January 15, 2019 Zoning and Platting Commission Agenda Question and Answer Report

4. **Resubdivision with variance:** [C8-2017-0308.0A - Cogbill Subdivision – Resubdivision of Lots 7 & 8; District 5](#)
- Location: 1001 Cogbill Street, South Boggy Creek Watershed
- Owner/Applicant: 2nd Street and 5th Street, LLC (Kirk Smith)
- Agent: Stansberry Engineering Co, Inc (Blayne Stansberry)
- Request: Approval of the Cogbill Subdivision - a resubdivision of Lots 7 & 8, composed of 4 lots on 0.83 acres. In addition, the Applicant requests a variance from Section 25-4-175 in order to resubdivide a lot using a flag lot design.
- Staff Rec.: **Recommended**
- Staff: [Don Perryman](#), 512-974-2786
Development Services Department

RESUBDIVISION OF LOTS 7 & 8 COGBILL SUBDIVISION

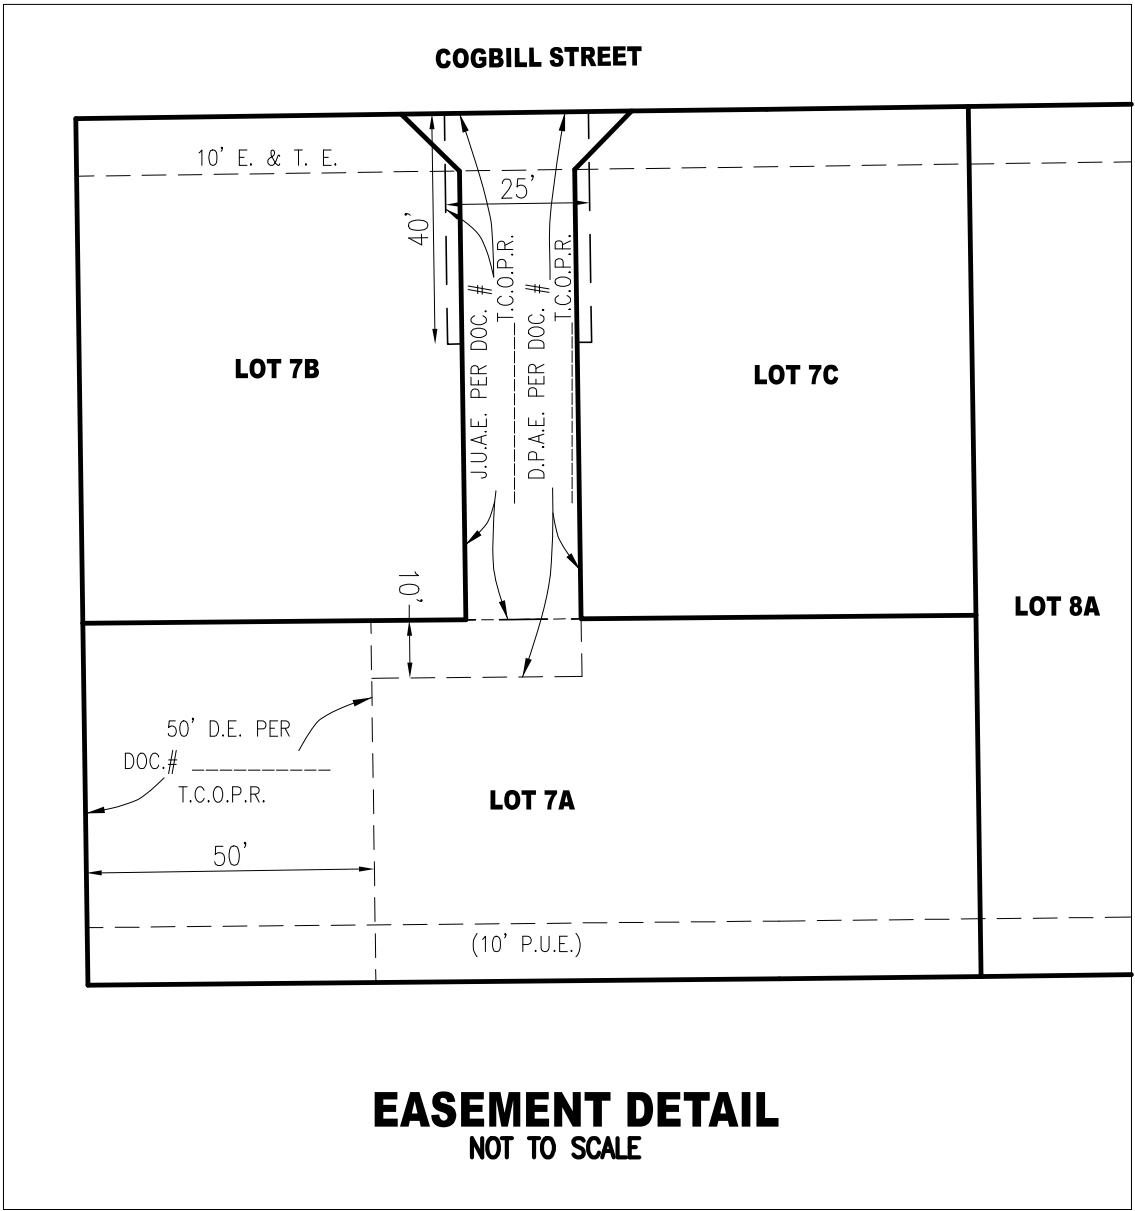
1. Why is Austin Transportation Department not requiring access to East Howard Lane? The portion of the property that immediately abuts East Howard Lane is owned by the same entity that owns the property associated with this case. Case C14-2018-0099 for the portion of the property that abuts East Howard Lane was withdrawn by the applicant this past December.
2. Why did the applicant change the zoning request from SF-6 to SF-2?

Due to environmental constraints, connection with the adjacent property to the south for access to E Howard Lane is impossible. Please see the attached site plan (Exhibit B) which shows a tributary in the 100-year floodplain crossing at the zoning boundary to the south. This area of the property is in the critical water quality zone. Therefore, if feasible, staff recommends vehicular access to the south and west properties.

Staff will review the right-of-way connection and block length standards at the time of the subdivision application.

RESUBDIVISION OF LOTS 7 & 8 COGBILL SUBDIVISION

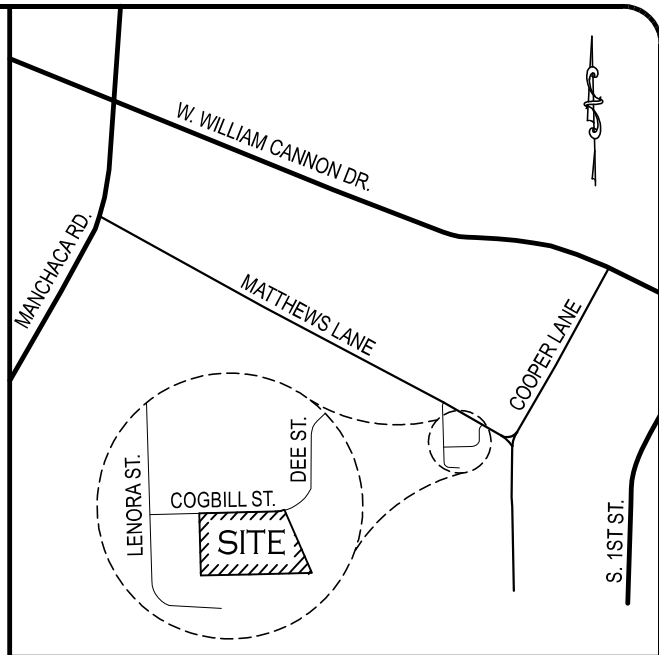
- 1) What is the length of the driveway for the flag lot?
- 2) Also, the letter from Stansberry Engineering states that the width of the driveway is 20' yet the easement detail on page 3 of the backup seems to indicate the width is 25'. Which is correct? The larger rendering indicates the driveway curbcut is 40'. Is this correct?

- 1) The applicant indicates that they are using 2008 floodplain data. Is that the most current data that can be utilized?
- 2) Can you send me fire's comments? I couldn't pull them up on Amanda. Why aren't they requiring sprinklers in the back residential lot. Is this because the driveway width is 20', not 15'.

The total width of the pole of the flag lot is 20 feet wide. The corners are “clipped” at Cogbill St. to allow room for the utility meters creating the 40 ft wide dimension. See attached plat. But the 40’ width quickly reduces to the standard 20’ width for the flag pole.

Originally proposed a 20’ driveway within the flag pole that would accommodate a fire truck for the rear lot. However, AFD requires the driveway to be 25’ wide. AFD only requires the 25’ width for a portion of the flag pole which is why the 25’ easement is shown and the flag pole remains 20’ wide. The total length of the flag pole is 78 feet and the total length of the 25’ easement is 40 feet.

The plat notes include a sprinkler system for the rear lot to mitigate any access issues. Please refer to note 21. We had originally proposed a 20' fire lane for a portion of the flag pole driveway which was not accepted by AFD. We provided a 25' wide easement to address AFD concerns. In addition, AFD required a engineered driveway which would require a geotech consultant to address that comment. The Owner felt the requirements for the pavement design would be too costly for the lot and that a sprinkler would be a less expensive option for addressing fire safety. The approved utility plan included as part of the plat review also noted a NFPA 13D system for the rear lot. AFD requires one of the other, not both – either a sprinkler or driveway access.

- EXTENDED OR OBSTRUCTED FIRE ACCESS SHALL BE MITIGATED WITH AN AFD APPROVED SPRINKLER SYSTEM FOR BUILDINGS ON LOT 7A.
